Whiteladies Road

Flood Alleviation and Footpath Scheme – Engagement Report

June 2022

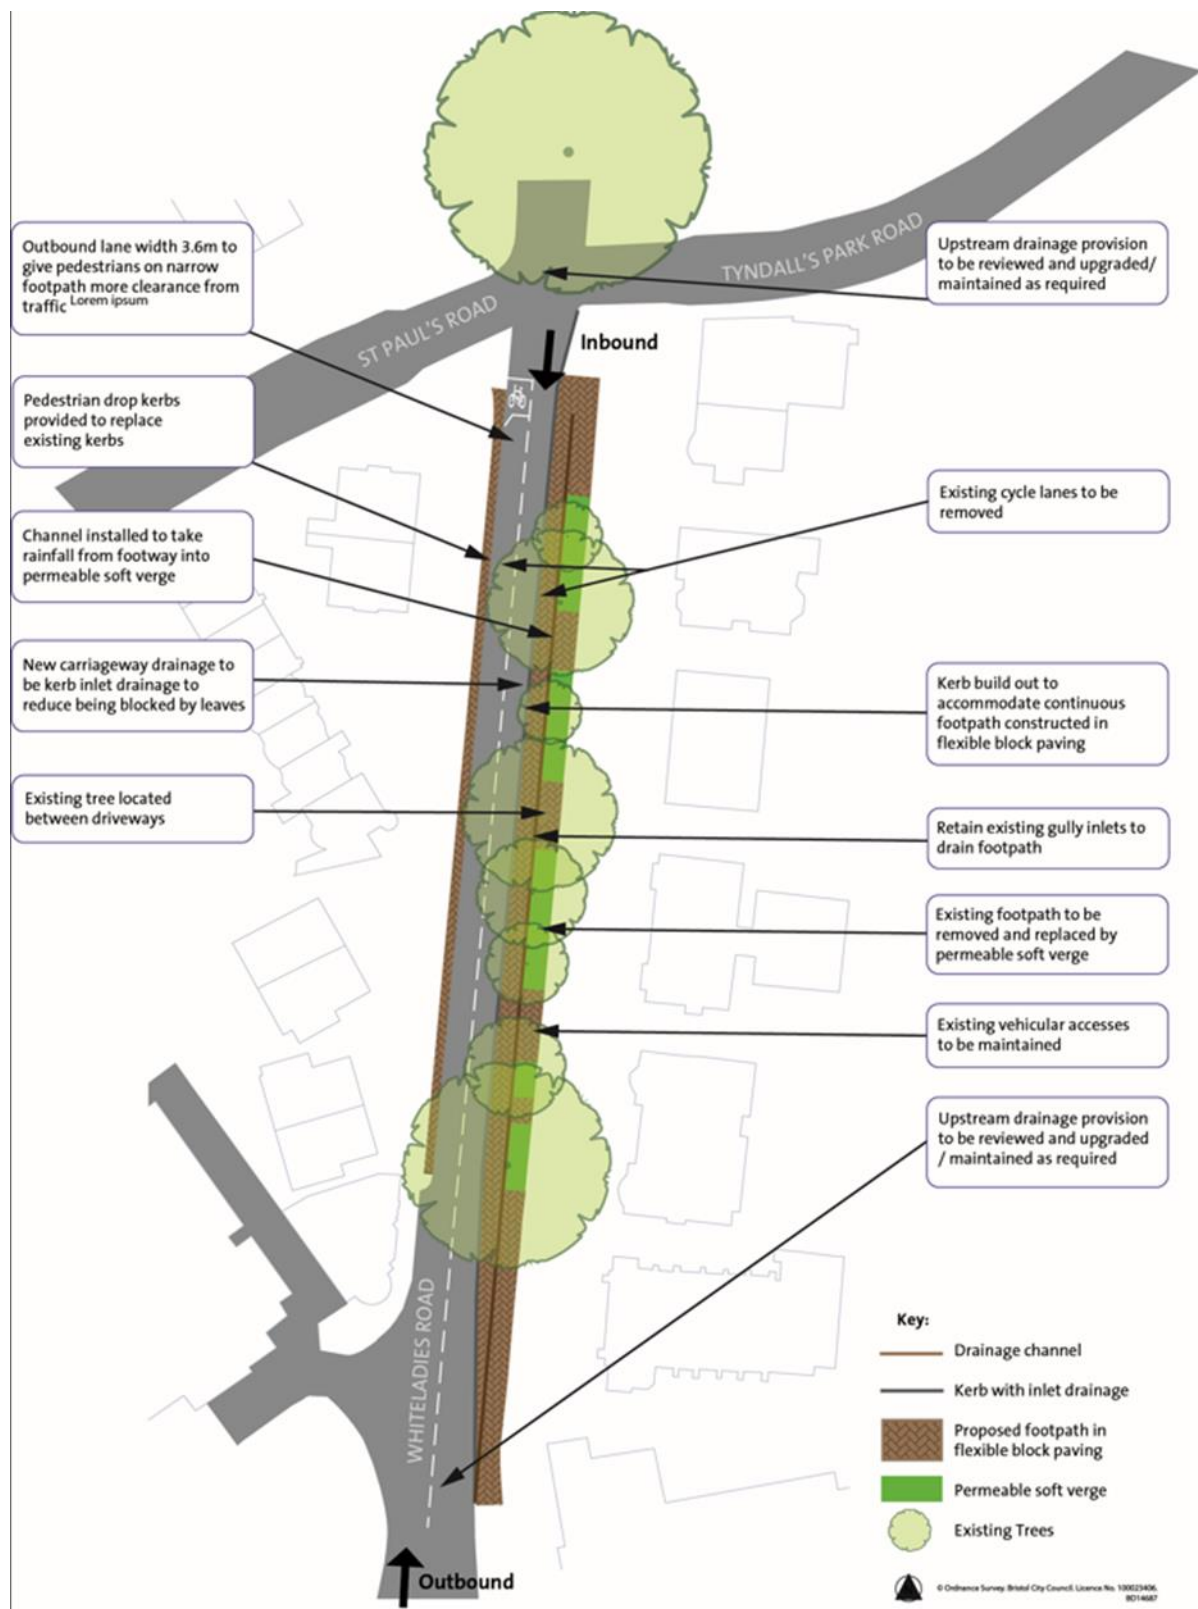
The group did not “agree that it is necessary to remove the cycle lanes from this section of the Whiteladies Road in order to meet the stated goals of alleviating the flood risk and improving the footways. We object to this plan on the grounds that:

- It increases the risk of injury & death to cyclists using the road and proposes no mitigation to address this danger.
- The tree root trip hazard risk to pedestrians (inbound) can be addressed by raising & resurfacing the existing pavement, without removing the cycle lane.
- The flood risk can be alleviated by upgrading the uphill storm drainage to prevent run-off from inundating this section of road and upgrading the road drains along this section (outbound side), without removing the cycle lane”.

They felt that the flood proposal would not cope with the severity of recent flash floods and suggested improving the storm drains uphill and maintaining existing drains. They suggested using ‘flexipave’ to deal with the tree roots and wanted negotiations with property owners for additional land to happen. They also commented on cycle and e-scooter parking and challenged the proposal for removing cycle lanes and felt it would make it unsafe for cyclists. They referenced policies and the number 2 bus route project and felt the proposals were poorly considered and fails to address the problems that are being addressed.

Whilst agreeing that the footways on the road need attention they proposed an alternative solution for both directions. On the eastbound side of footway, they propose:

- “Resurface the existing footway at a slightly higher level to achieve maximum width and provide a flat surface above the level of the tree roots.
- The slightly raised surface should maintain a continuous footway across driveways, so the driveways may need extra drainage beneath the footway.
- Relocate the cycle stands situated between the trees (which seem rarely used).
- Provide wider sections of footway (by about half a tree width) between the trees to allow pedestrian 'overtaking' - this is what effectively happens already.
- Put grass verges, with kerbs to the road that include drainage inlets, between the trees (using the remaining half a tree width) providing permeability to help drainage and tree irrigation.”

On the western side of the footway, they propose “to request that the driveways are raised to produce a continuous, level footway with a short vehicle ramp to the road”.

Ineffective – permeable verges would not cope with large volumes of water

Unsafe – pedestrians would be using a footway next to a road whereas now they are shielded by the trees and the removal of the cycle lane creates a dangerous situation for cyclists
 Lack of coherence – many places on wider route where advisory lanes break at junctions so to remove a lane altogether would be in contrary to environmental and traffic policies.

The club were disappointed at the proposal as the section of road is a thoroughfare for students who live in Cotham, Redland and Clifton and the removal of the cycle lanes will make it unsafe. “The cycle lane allows bus drivers to pass cyclists safely and its removal would make this much more challenging. The cycle lane along this section of Whiteladies also makes the interaction between traffic and the highly popular Voi scooters a lot safer, with many students now choosing these as means of transport.”

“We instead propose the flooding problem is fixed by combining a drainage channel between the pavement and cycle lane and building new drains into the road. The pavement could be widened by simply releveling the existing pavement and fixing the damage caused by tree roots, without needing to remove the cycle lane. Permeable drainage areas could be used around the base of the trees, with these areas also utilising kerb blocks with drainage holes.”
